**Lot 17 Woodbridge South**  
**41 Avents Way**  
**Fuquay Varina, NC 27540**

**PLAN 1**  
**The Clayton - LH**

**PLAN 1 - THE CLAYTON - LH**

OPT. FIREPLACE @ EXT  
COVERED PORCH

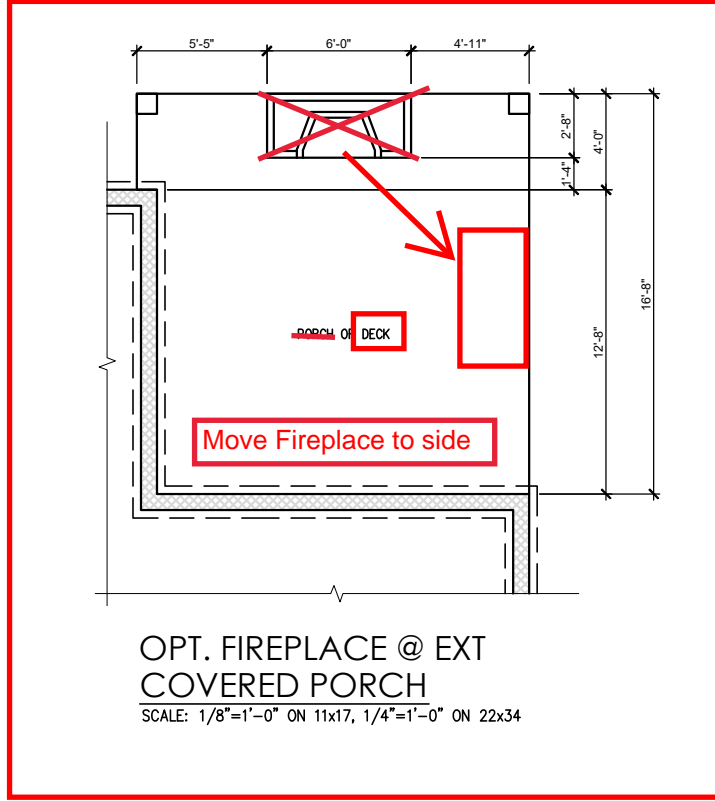
Opt Extended Covered Porch w/  
SIDE Fireplace  
see Page 1.2.1c

FIRST FLOOR PLAN 'CRAFTSMAN'  
SCALE: 1/8"=1'-0" ON 11x17, 1/4"=1'-0" ON 22x34

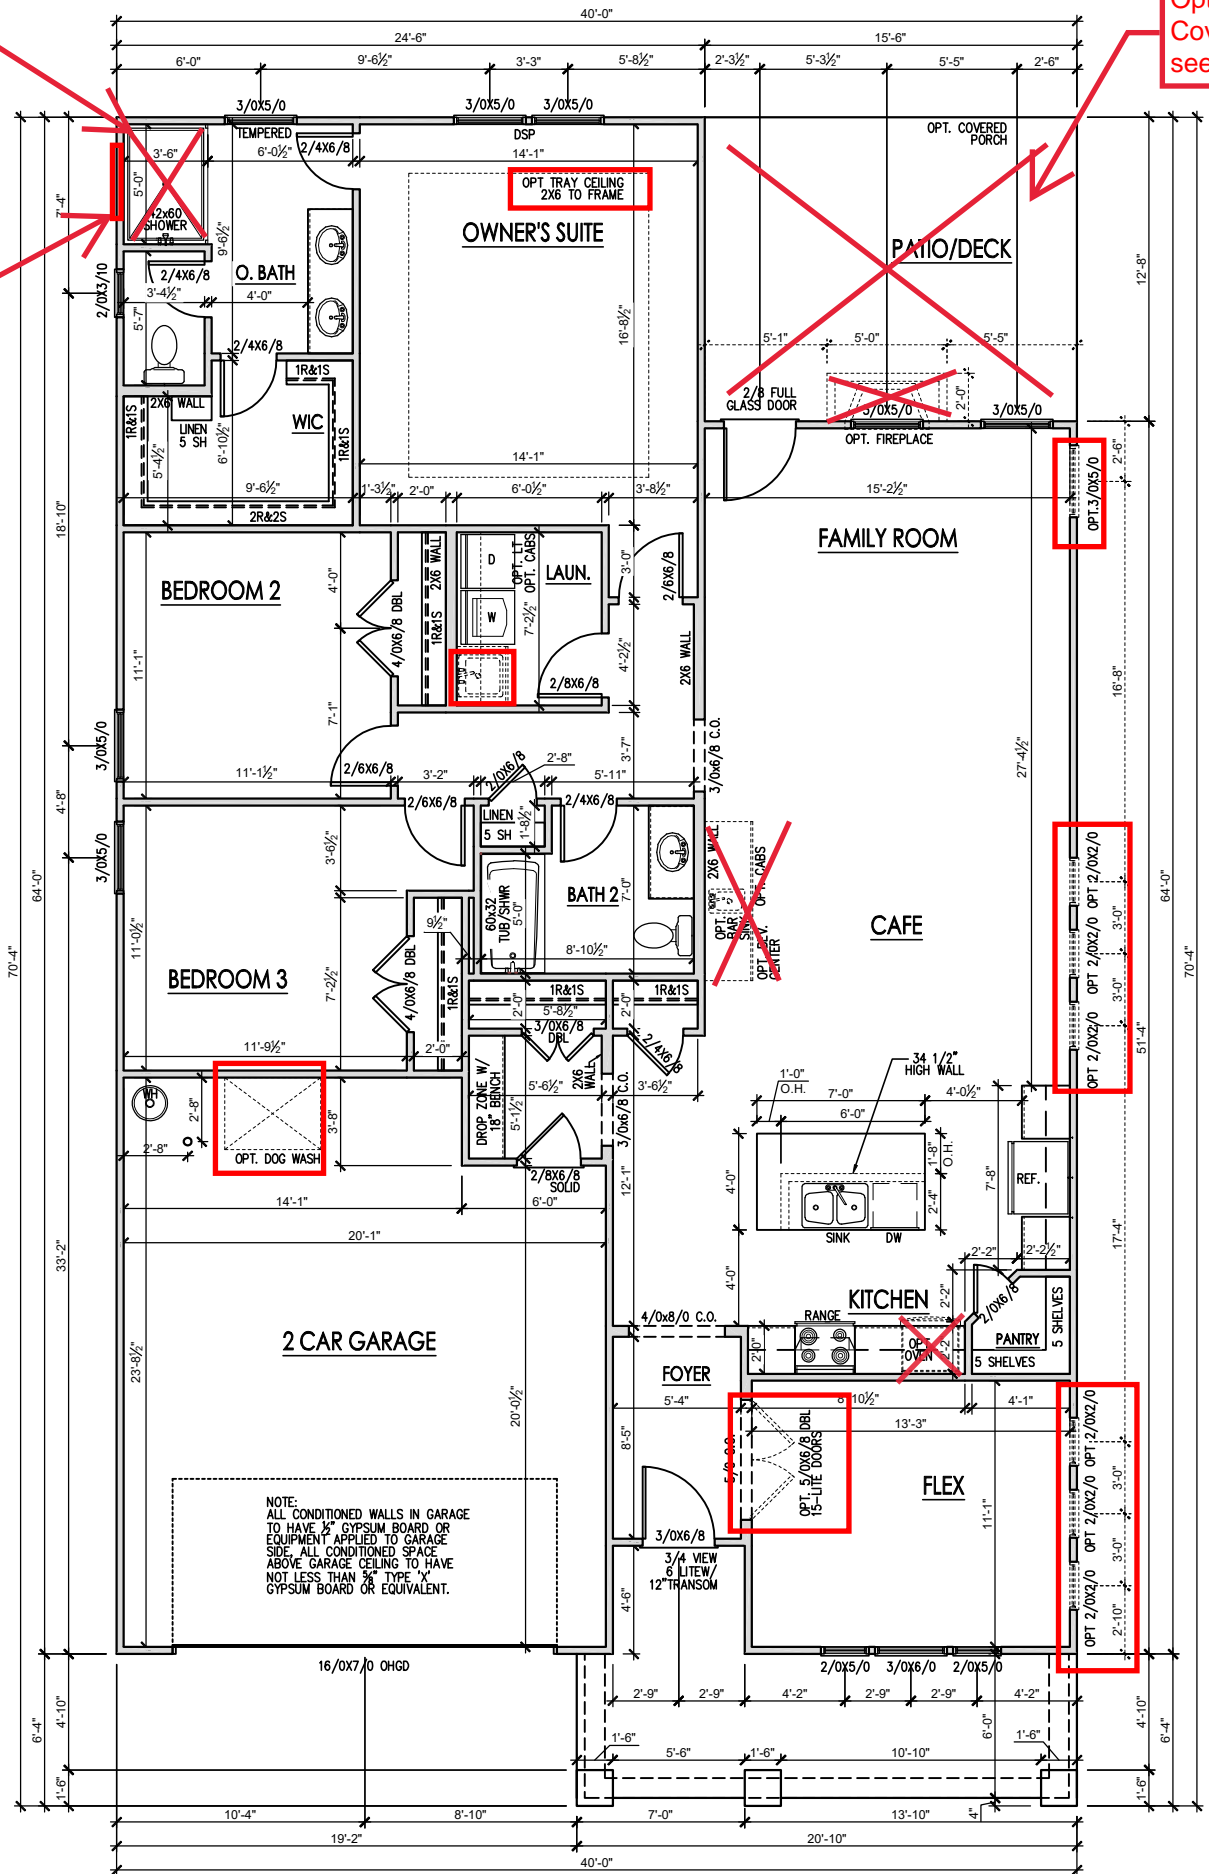
Opt Shower w/18" Seat see Page 2.1.1c

Add 4/0 x 1/0 transom at Owner's Shower

Opt Extended Covered Deck see Page 2.5.1c

OPT. SHOWER  
SCALE: 1/8"=1'-0" ON 11x17, 1/4"=1'-0" ON 22x34

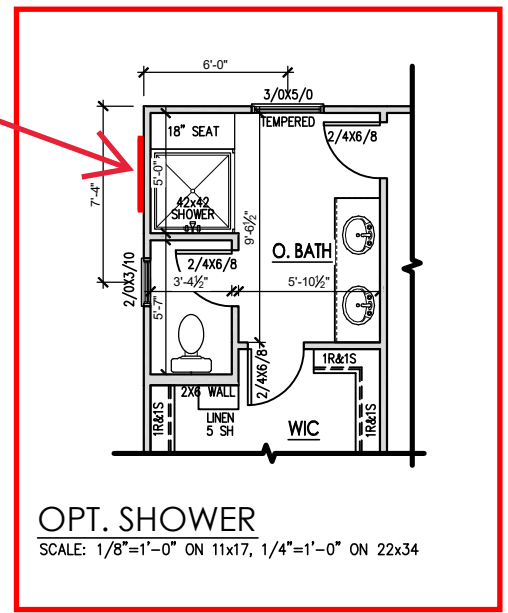
Add 4/0 x 1/0 Transom at Owner's Shower

**PLAN 1 - THE CLAYTON - LH**  
Ext Covered Porch Plans & Elevations (Crawl) 'Craftsman'

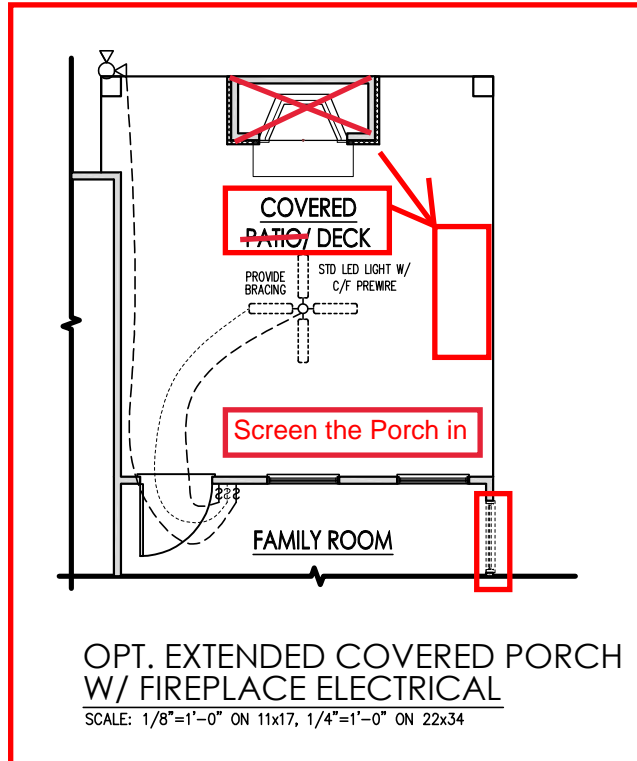
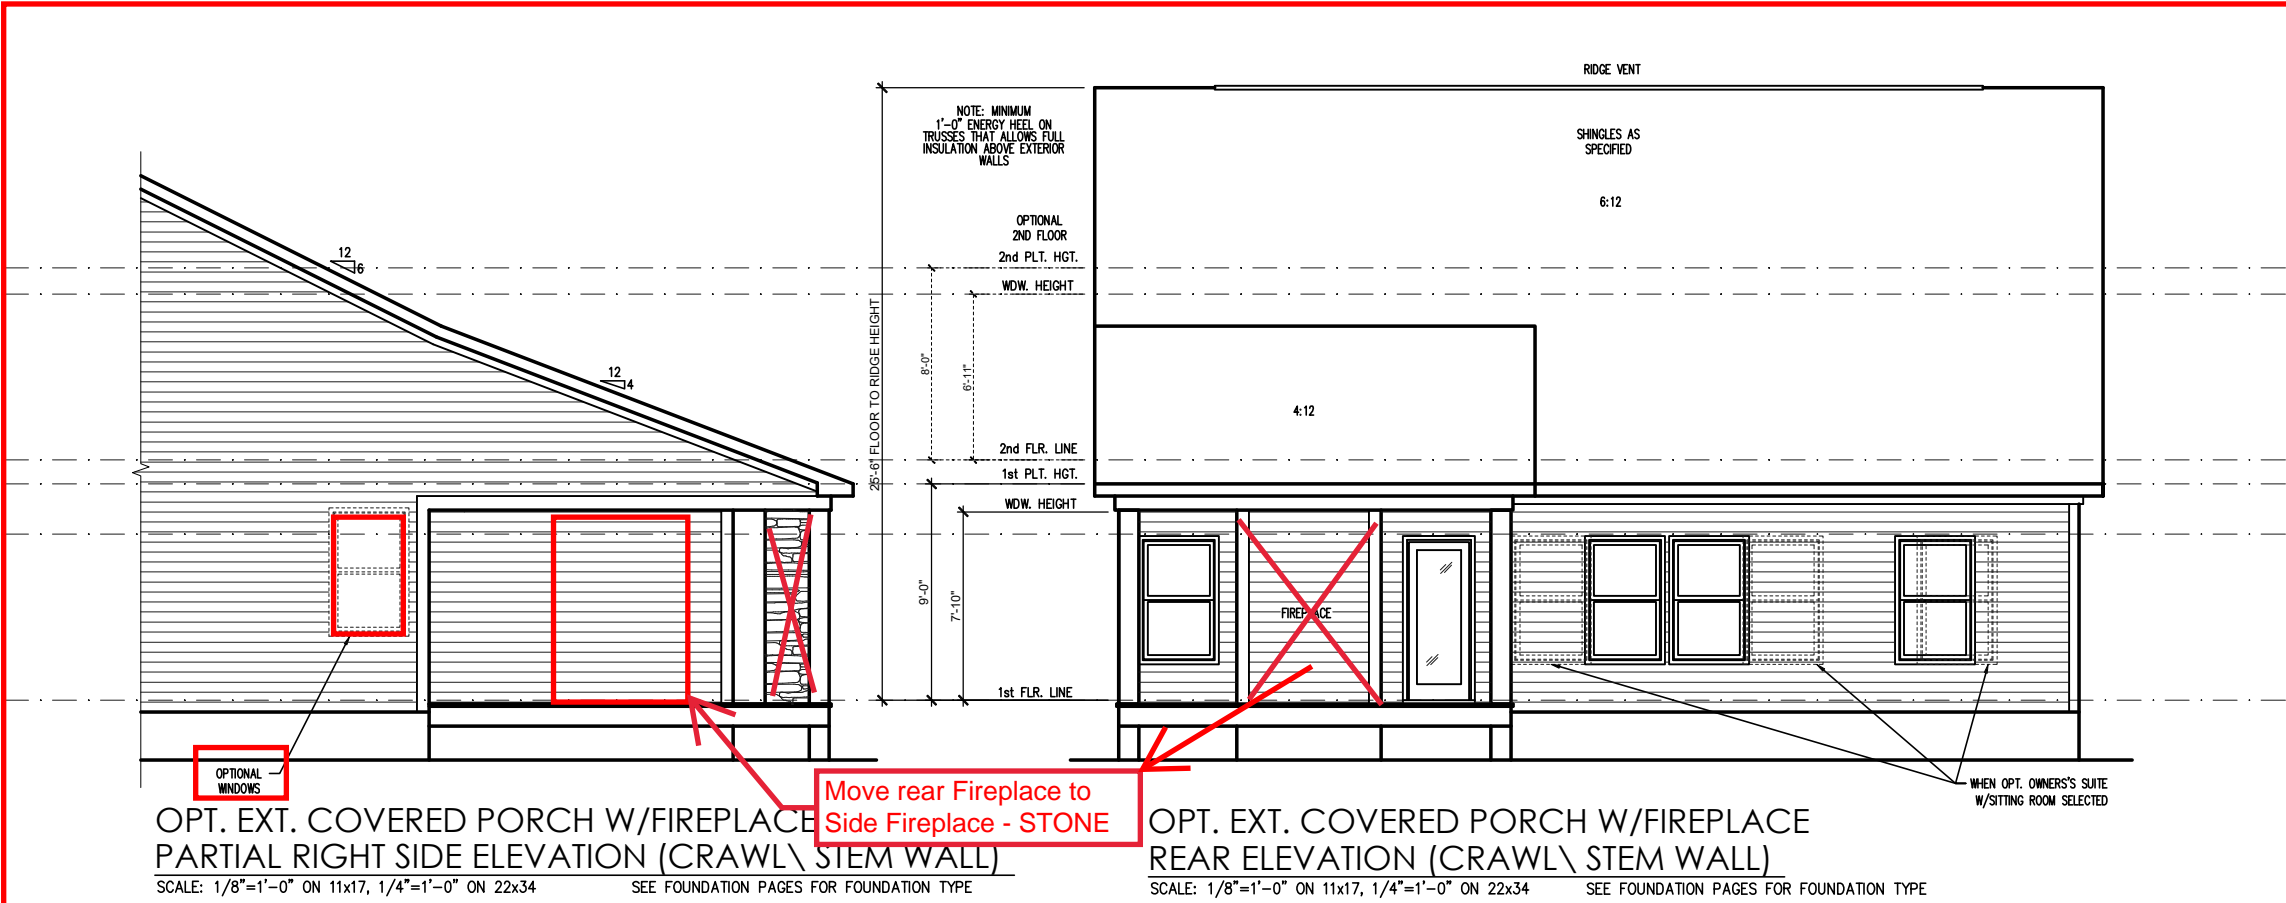
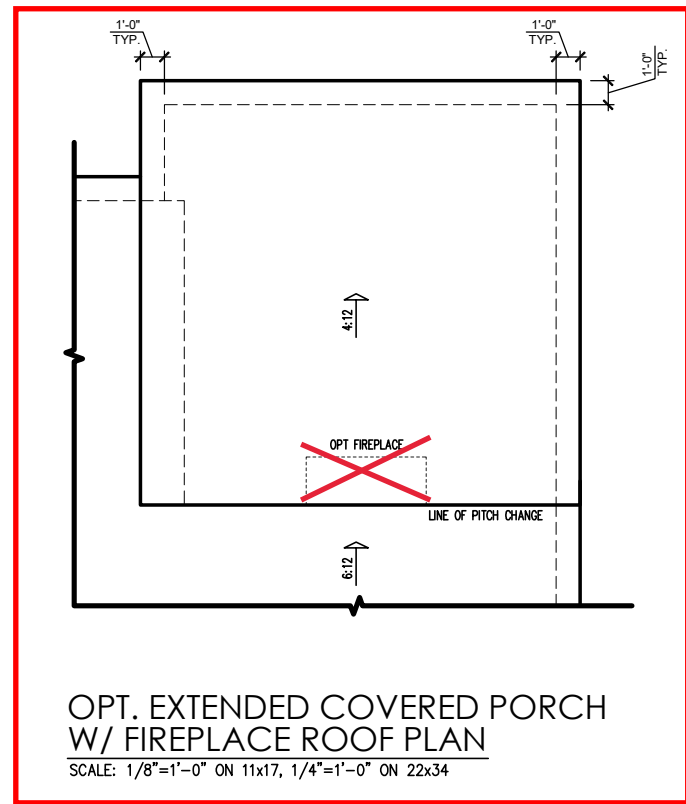
Fireplace will be in STONE

Screen the Porch in

Move rear Fireplace to Side Fireplace - STONE

**PLAN 1 - THE CLAYTON - LH**  
Side Elevations (Crawl or Stem Wall) 'Craftsman'

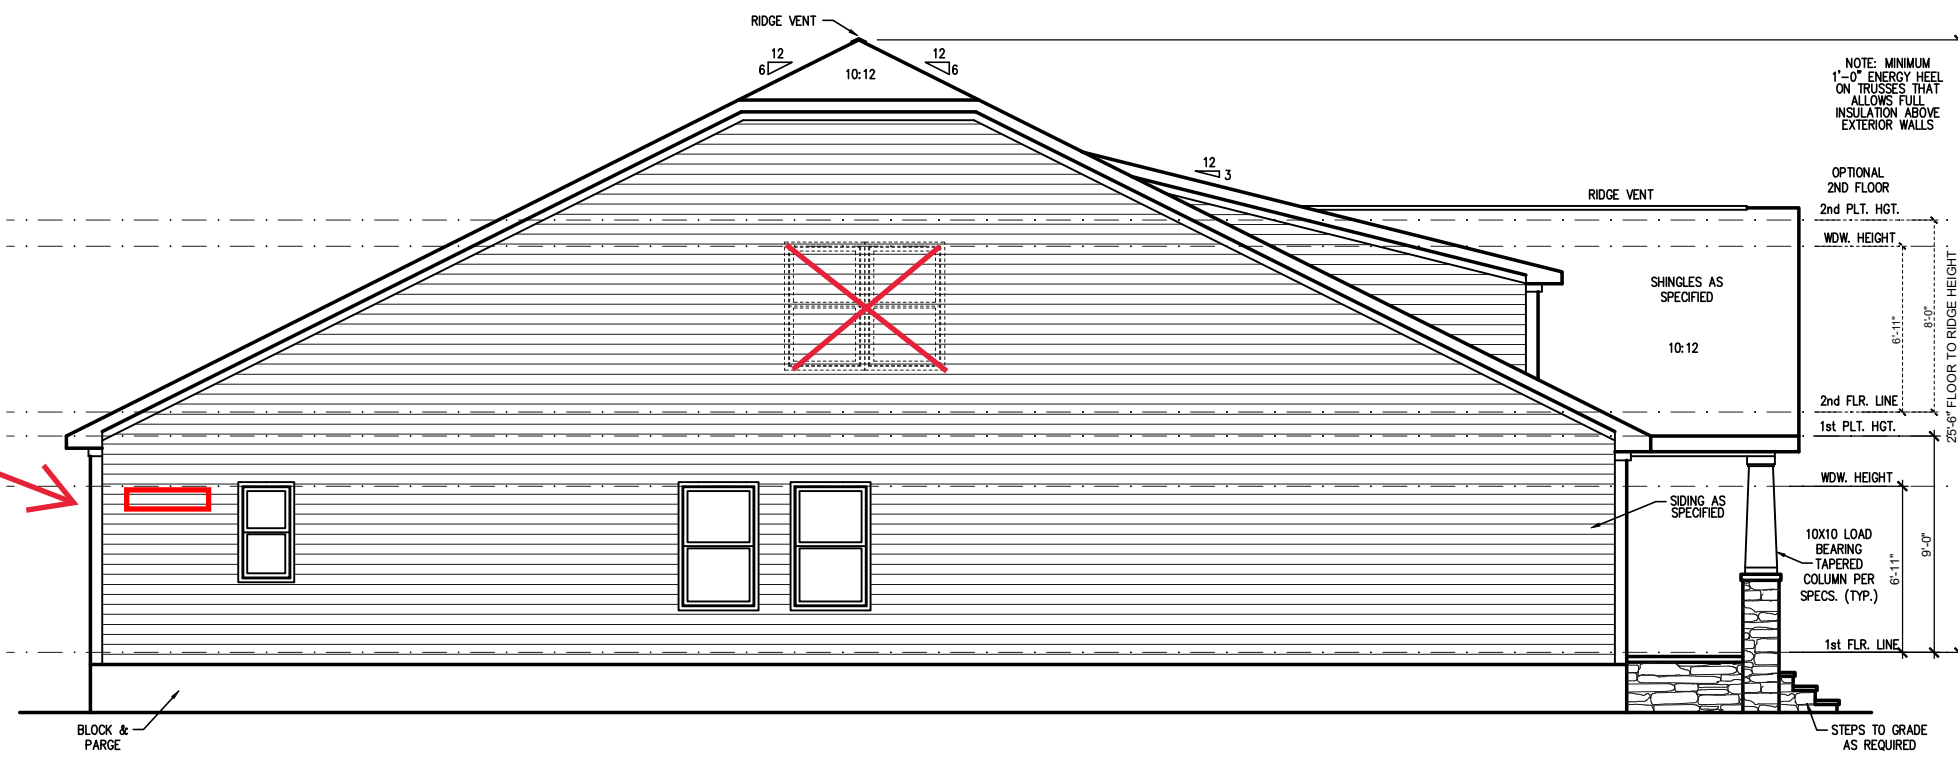
Opt Extended Covered Deck see Page 2.5.1c

add 4/0 x 1/0 Transom at Owner's Shower

**'LOW COUNTRY' BASE CRAWL FOUNDATION**  
SCALE: 1/8"=1'-0" ON 11x17, 1/4"=1'-0" ON 22x34  
NO 2nd FLOOR

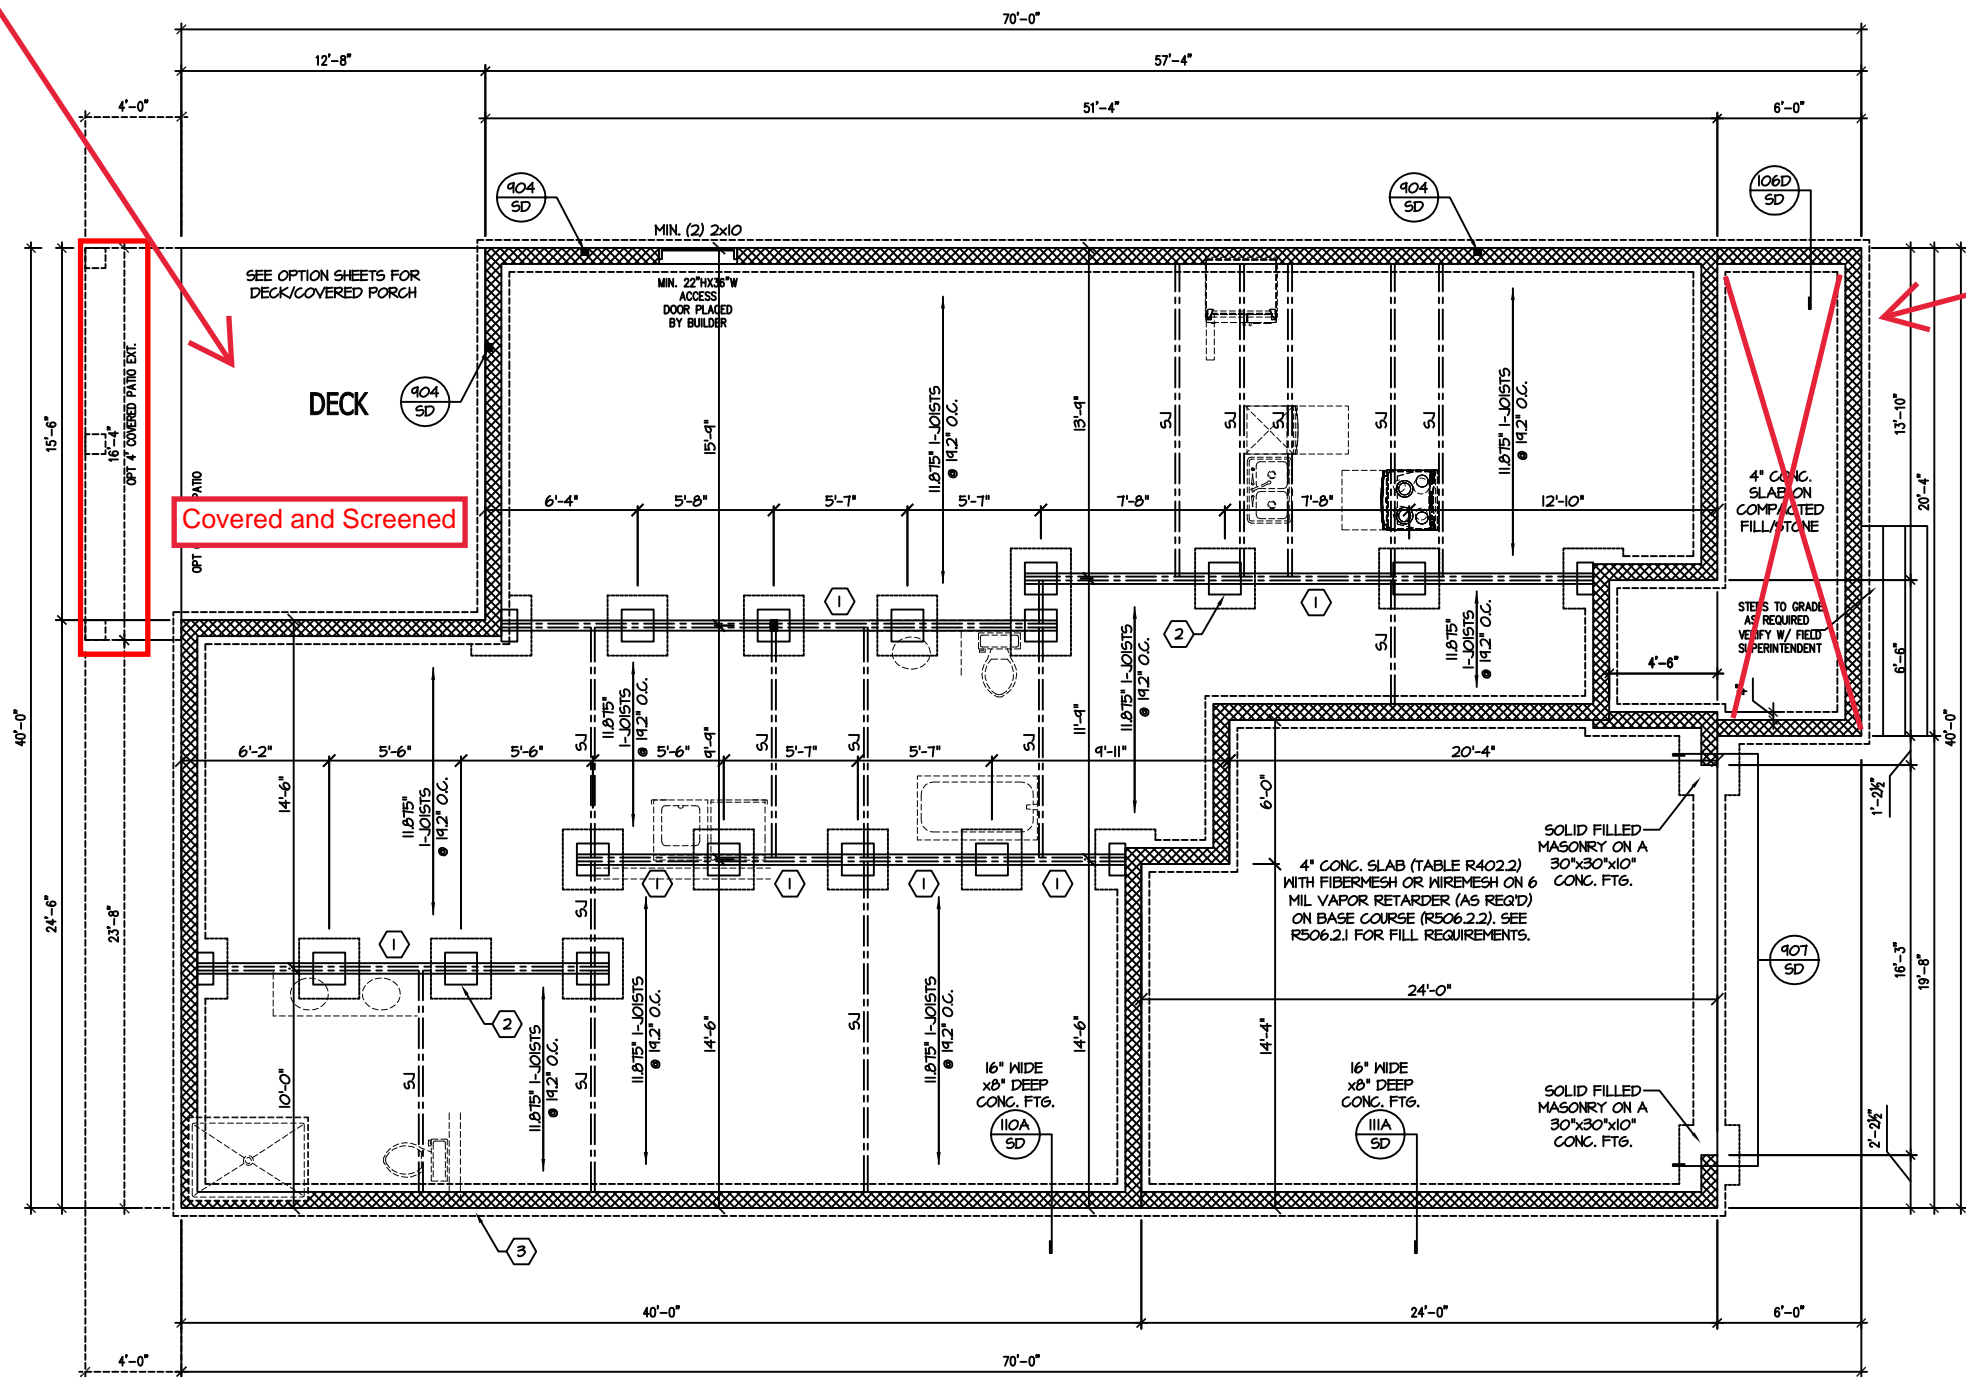
Opt Extended Covered Deck  
w/ side Fireplace  
wrapped in Stone  
Screened  
see Page S-1.3

Craftsman Elev.  
Front Porch  
see Page S-1.2

**OPT. FIREPLACE @ EXT COVERED PORCH OR DECK**  
 SCALE: 1/8"=1'-0" ON 11x17, 1/4"=1'-0" ON 22x34  
 NO 2nd FLOOR

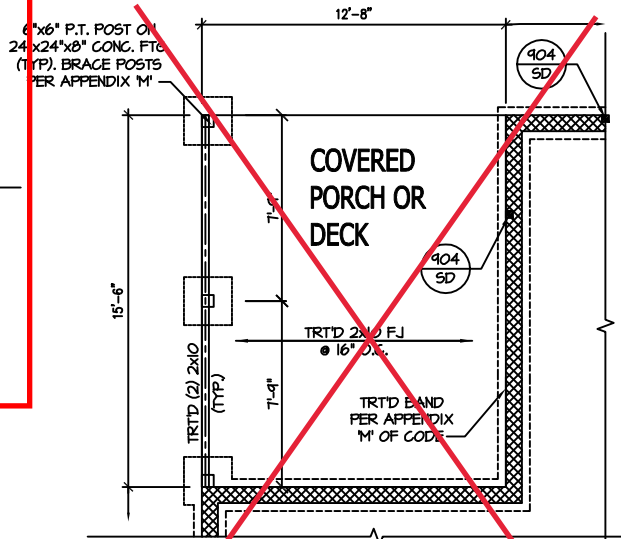
move Fireplace to side wrapped in Stone
